SUBJECT: NFPA 1 Proposed Tentative Interim Amendment (TIA) No. 1709

NFPA 1-Proposed 2024 Edition

TIA Log No.: 1709

Reference: (NFPA 58 extracts) 2.4, Various paragraphs in 3.3 and Chapters 42, 50 and 69

Figure A.69.3.5.1.1 Illustration of Separation Distances from Containers to the Line of Adjoining Property ~~that That can Can be Be~~ Built Upon. [58:Figure A.6.4.1.1]

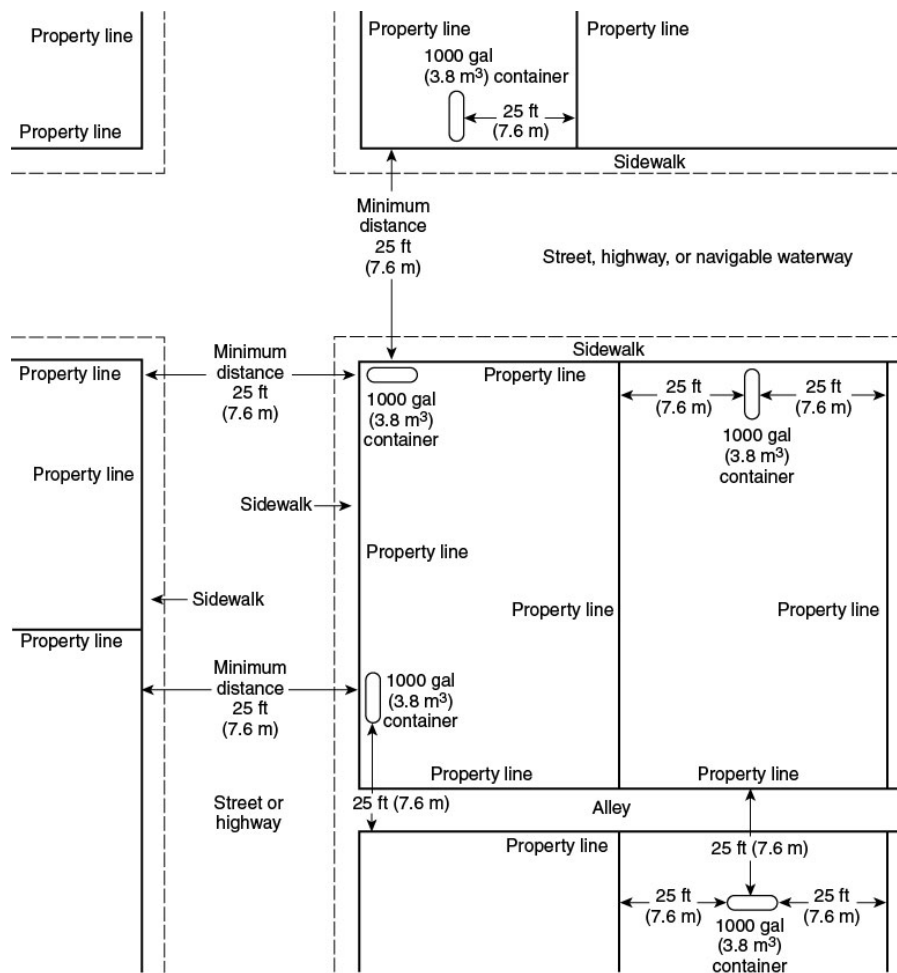
The “Line of Adjoining Property ~~that That can Can be Be built Built upon Upon~~” refers to the property boundaries of the property adjacent to the one ~~upon~~ where the container is located. This is illustrated in Figure A.69.3.5.1.1 and in Figure I.1(a), Figure I.1(b), and Figure I.1(c) of NFPA 58, taking into consideration a condition that involves property on the other side of a street, highway, navigable
